Licensee's Post Written Examination Comments and NRC Resolutions

Comments on Indian Point 2 July 2010 Initial NRC License Examination

nrc post exam data - Thu Aug 12 15:58:22 2010

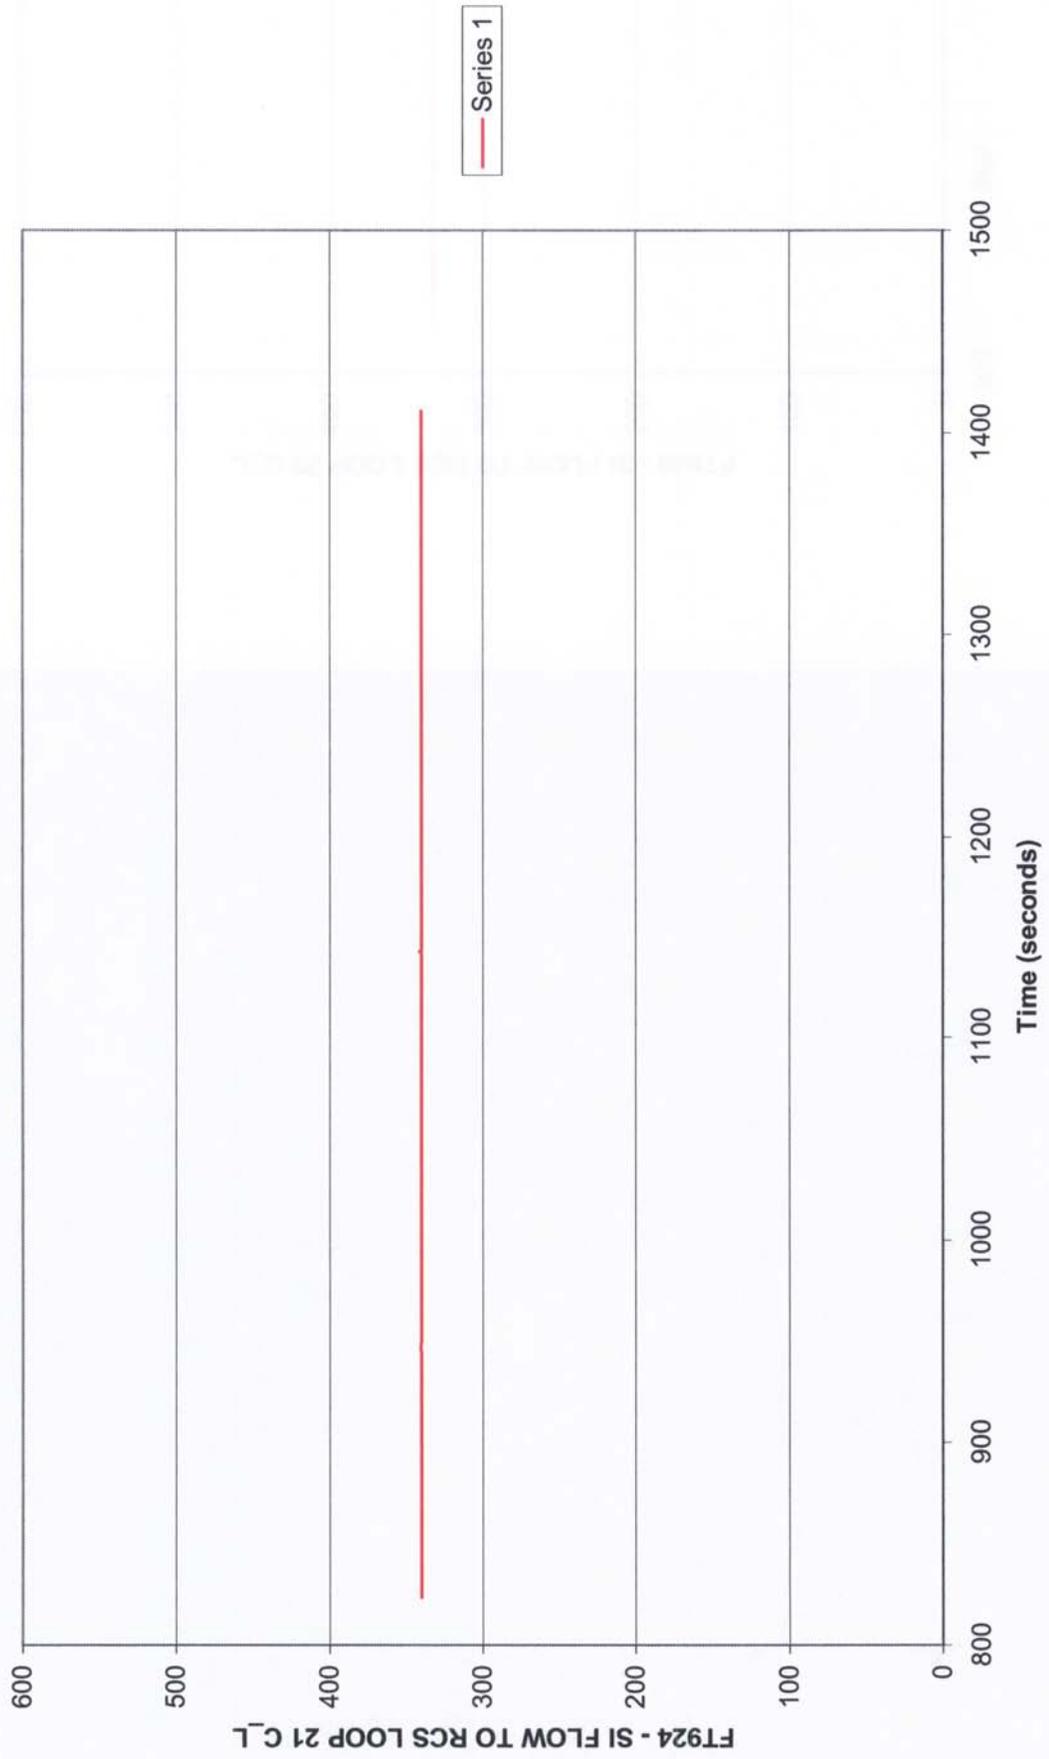
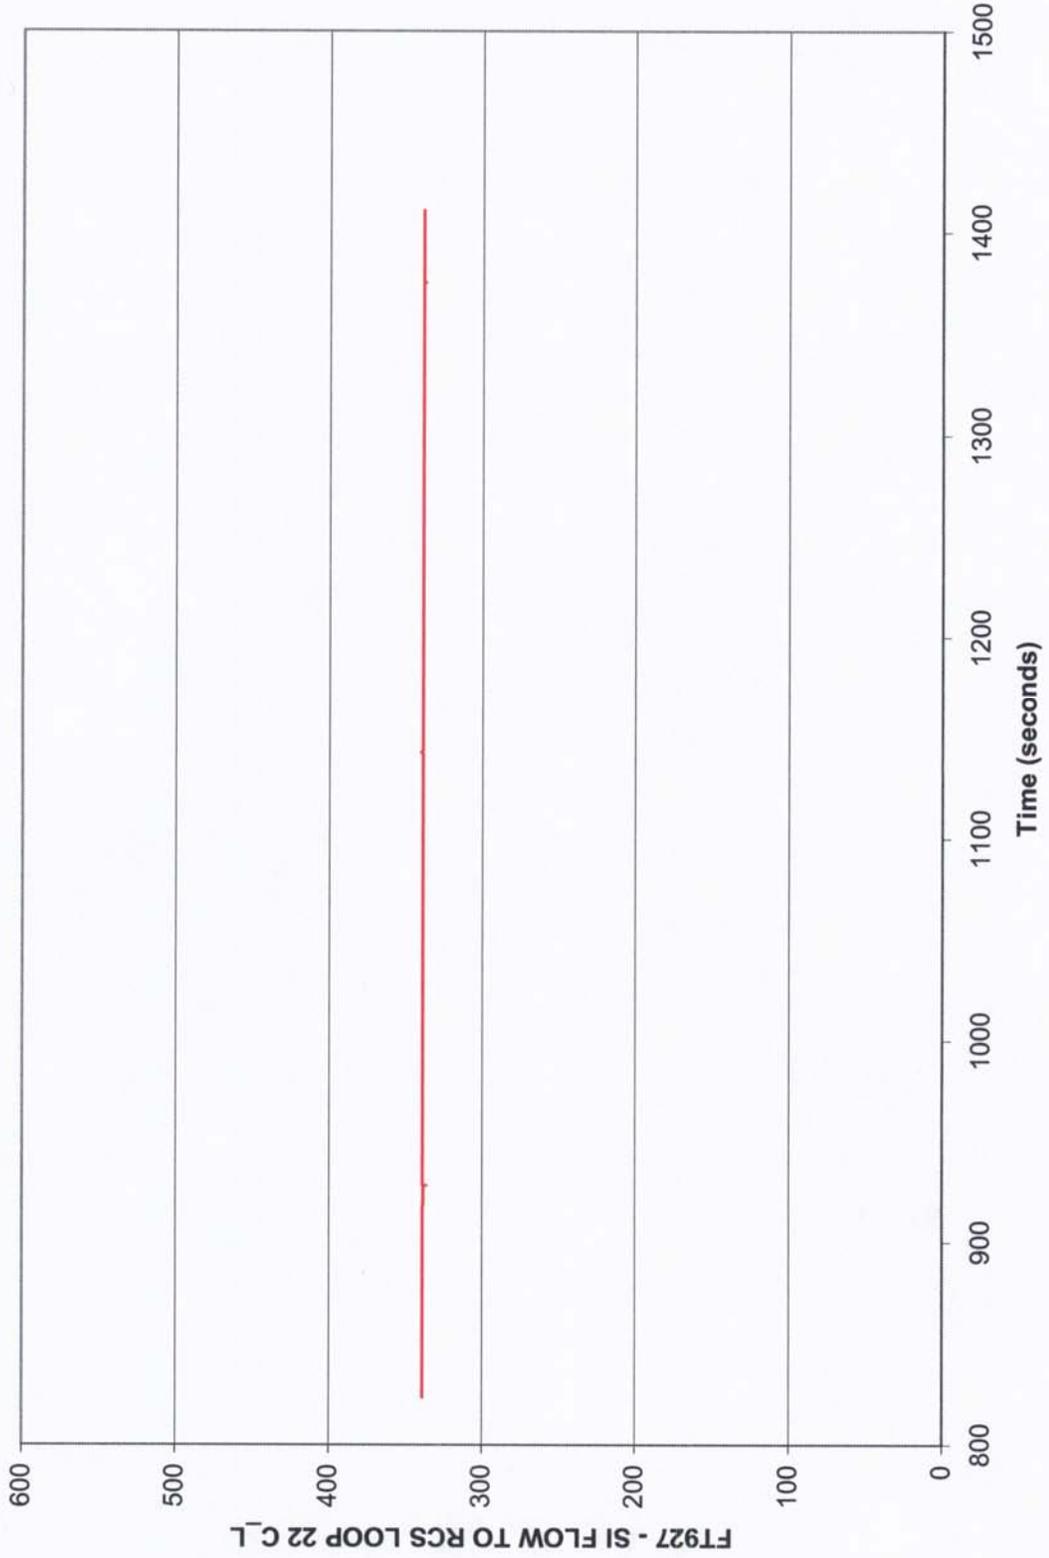
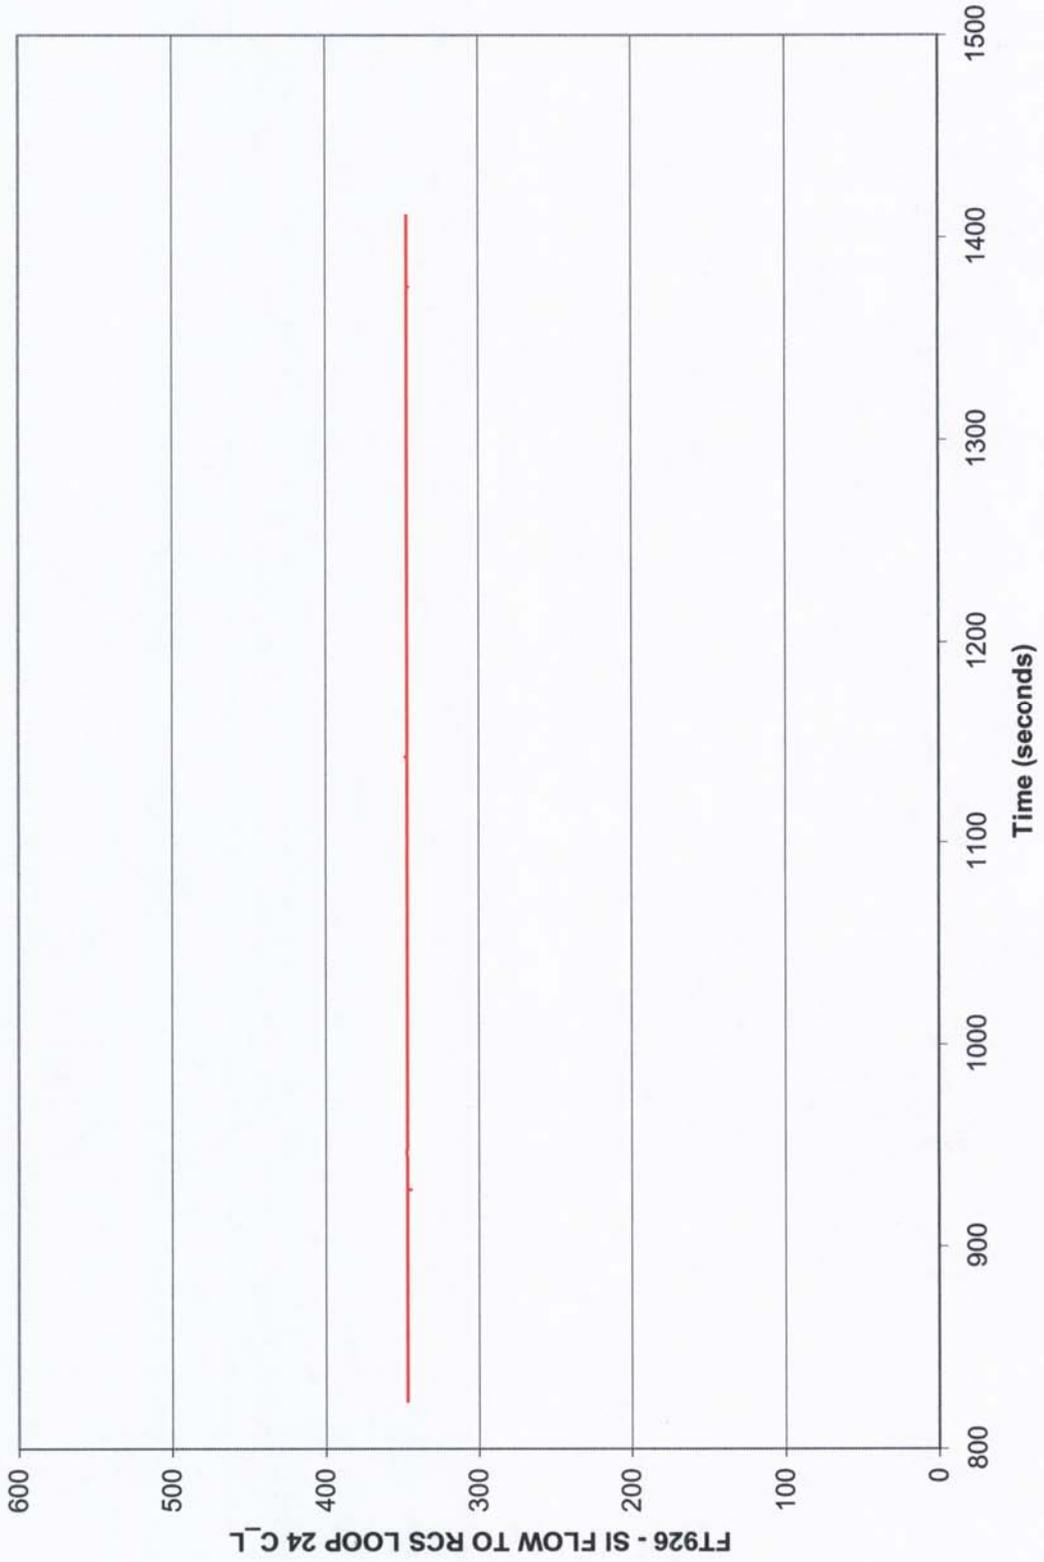
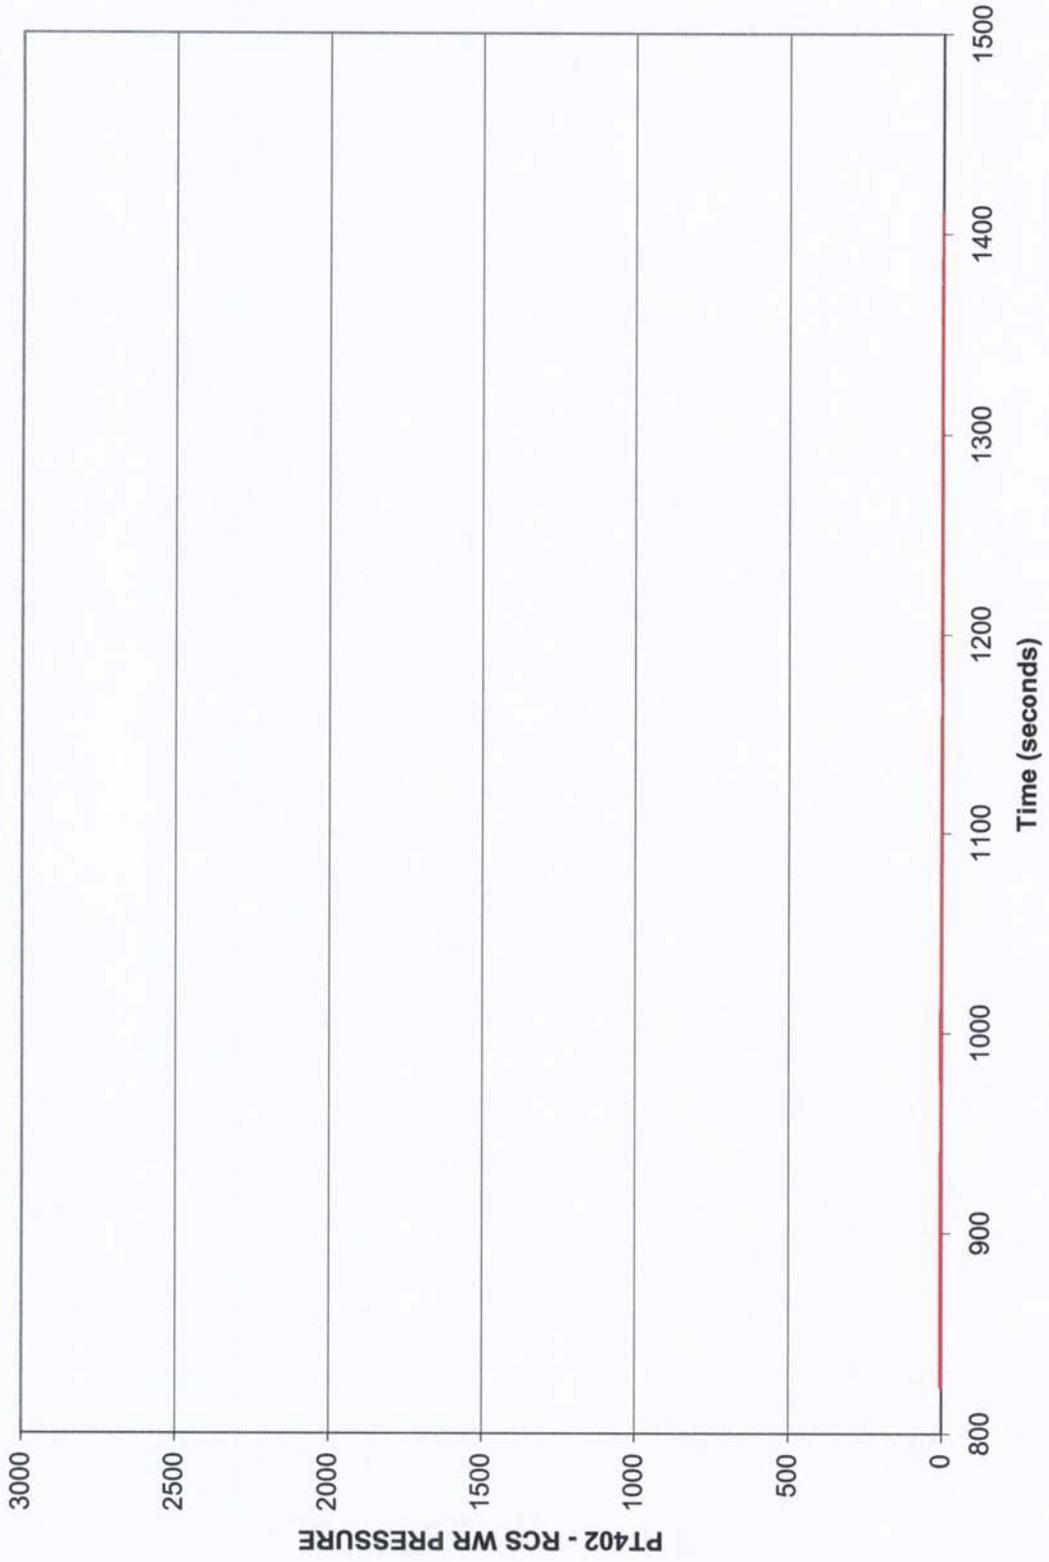
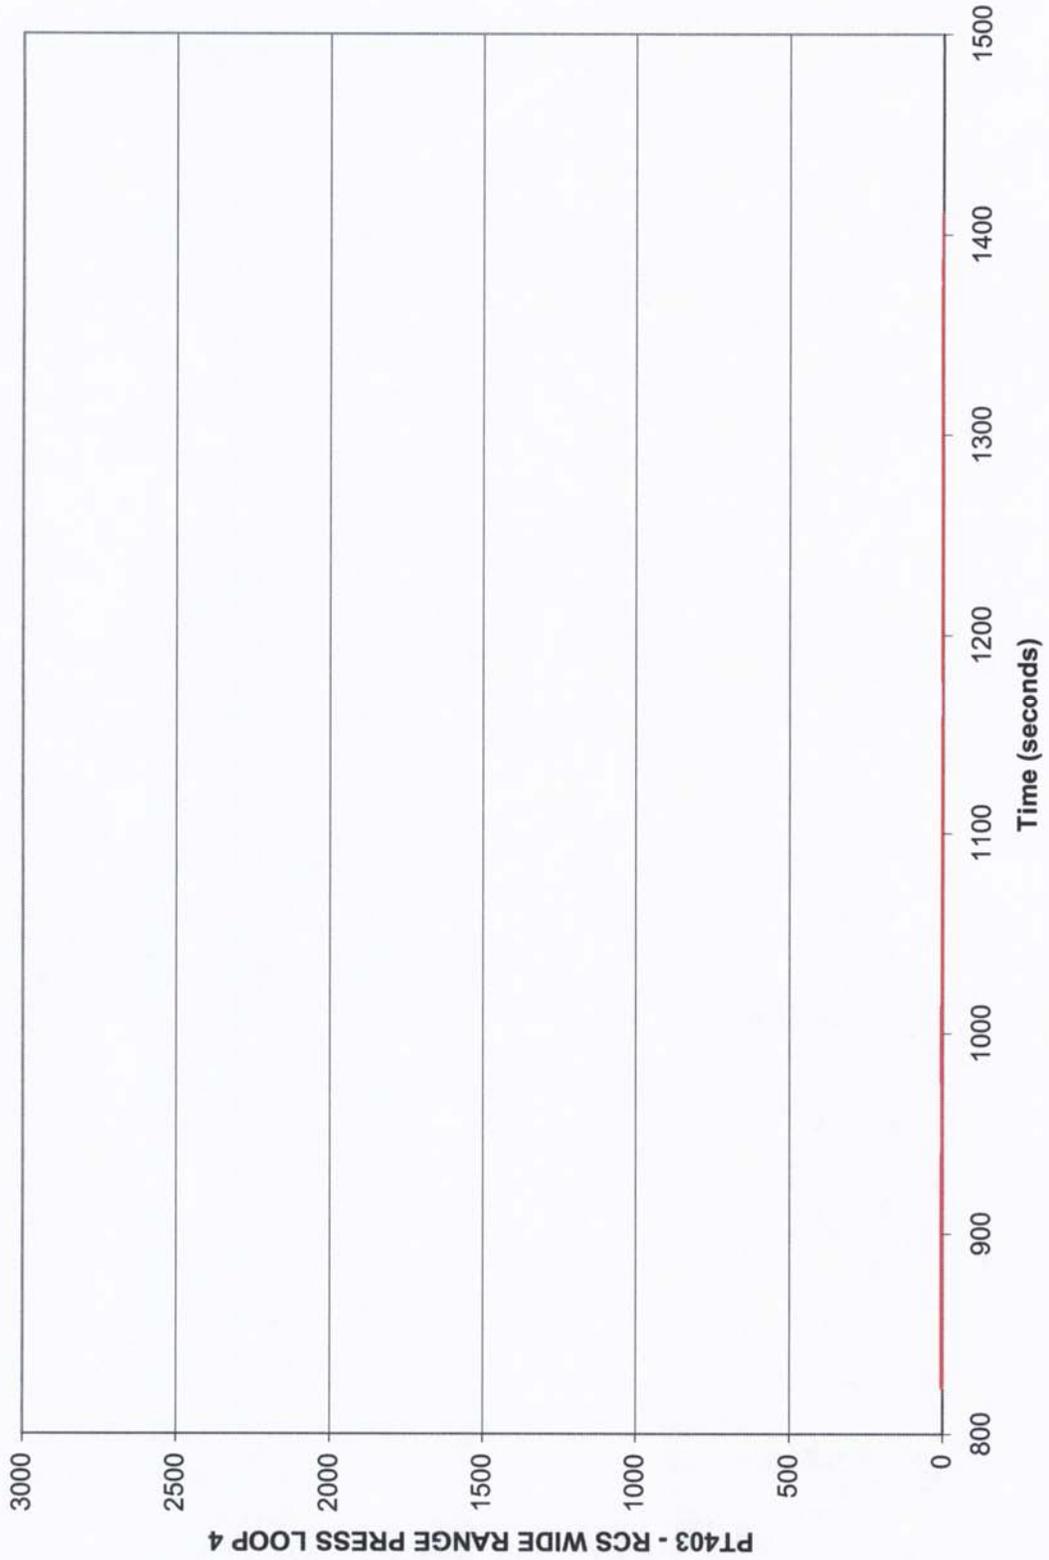
IPEC disagrees with the answer key that Answer B (22 Charging Pump prior to manipulating Recirc Switches in ES-1.3, Transfer to Cold Leg Recirculation) is the correct answer. Although the charging pump could be secured first, it would be secured in 2-E-1, prior to entering 2-ES-1.3 for the following reasons:

- Page 9 of 2-E-1 contains a CAUTION that states “If RWST level decreases to less than 15 ft. charging pumps that are started or running should be monitored for loss of suction which may result in pump damage.” In the IPEC Unit 2 Simulator the candidates have observed that charging flow begins decreasing when RWST level lowers to 12 ft, with charging flow significantly reduced by the time that RWST level reaches 11 ft. The operators have been trained to secure the charging pumps when they observe charging pump flow decreasing due to loss of suction. During initial charging pump operation starting in 2-E-0, the charging pump is placed in service at maximum speed with charging flow at approximately 65 gpm. Data taken during LBLOCA in the Unit 2 simulator supports that charging pump discharge flow drops significantly (see attached). When RWST level reaches approximately 12.7’, flow is observed to begin lowering with the charging pump still at maximum speed. At approximately 10’ in the RWST, flow has lowered to 9 gpm. Operators are trained to secure a piece of running equipment when its suction source is lost.

- Answer B does not correctly identify the procedural guidance for securing the charging pump. Although Step 4 of 2-ES-1.3 stops all charging pumps to reduce 480V bus loads, the charging pumps would already be secured in 2-E-1 when RWST level lowered to less than 12 ft but prior to transitioning to 2-ES-1.3 at 9.24 ft.

The NRC position is that "B" answer would always be a correct answer based on the procedural guidance alone: 1) The procedural guidance in 2-E-1, Page 9, CAUTION that states "If RWST level decreases to less than 15 ft. charging pumps that are started or running should be monitored for loss of suction which may result in pump damage." However, this guidance does not provide explicit direction to secure the charging pump(s) based on this caution and in some cases it may be desirable to maintain the pump(s) running as long as possible; 2) In contrast, 2-ES-1.3 does provide explicit guidance on when the charging pumps must be secured. The CAUTION just prior to step 4 states, "Any pumps taking suction from RWST should be stopped if RWST level decreases to 3.0 ft for SI and charging pumps....";

3) 2-ES-1.3, step 4, provides further direction to stop all charging pumps and this is done prior to performing procedural step 6, "Place Safety Injection Recirc Switches 1 AND 3 to ON" that provides the bases for selecting answer choices "C" or "D". The question stem asks which of the following pumps could be secured first, answer choice "B" states, "22 Charging Pump prior to manipulating Recirc Switches in ES-1.3, Transfer to Cold Leg Recirculation". The licensee has provided justification for stating charging pumps may be secured earlier using the guidance in 2-E-1. Given a LBLOCA condition, the charging pumps will always be secured first in the sequence whether using the guidance in 2-E-1 or by using the guidance contained in 2-ES-1.3. Finally, if for any reason the charging pumps are not secured prior to entering procedure 2-ES-1.3 then this procedure directs that the charging pump(s) would be secured prior to taking the action in procedure step 6 that provides the basis for selecting answer choice "C" or "D". The NRC disagrees that key answer B is incorrect.

The question stem asks the candidates to determine two things: 1) which pumps could be secured first, and 2) what is the procedural guidance for this action [securing the pumps]? The NRC concludes that answer "C" (22 SI Pump from Recirc Switch 1 in ES-1.3, Transfer to Cold Leg Recirculation) should also be accepted as a correct answer for the following reasons: 1) The procedural guidance in 2-E-1, Page 9, CAUTION states "If RWST level decreases to less than 15 ft. charging pumps that are started or running should be monitored for loss of suction which may result in pump damage." In addition, the 2-E-1 Background document, page 56, basis section indicates that a section of the charging pump suction piping is at an elevation of 15 feet above the bottom of the Refueling Water Storage Tank (RWST). If RWST level decreases to less than 15 feet a vacuum will be drawn in that section of the piping that may cause a decrease or loss of charging pump suction pressure and flow; 2) The operators have been trained to secure the charging pumps when they observe charging pump flow decreasing significantly due to loss of suction in order to protect plant equipment; and 3) The Unit 2 simulator data provided by the licensee for Large Break Loss of Coolant Accident (LBLOCA) indicates that charging pump discharge flow drops significantly when RWST level lowered to less than 12 feet. 4) Transitioning to 2-ES-1.3 is not done until level in the RWST level decreases to less than 9.24 ft. Therefore, based on guidance in 2-E-1, the simulator data and training provided to the operators, it is conceivable that the operators would be expected to secure any running charging pumps prior to transitioning to procedure 2-ES1.3 (i.e., especially since all other systems are operating normally as the stem of the question indicates. It follows then that if charging pumps are secured earlier in 2-E-1 for all of the reasons stated above (i.e., prior to transitioning to 2-ES1.3) then 22 SI pump could be the first pump secured in 2-ES-1.3.

The NRC has determined that in both cases noted above the applicant could transition to 2-ES-1.3 by appropriately using the station procedures and cautions. The result is that the charging pumps could be on or off depending upon the use of the caution step in 2-E-1, prior to entering 2-ES-1.3, which could lead to either answer B or C being correct.
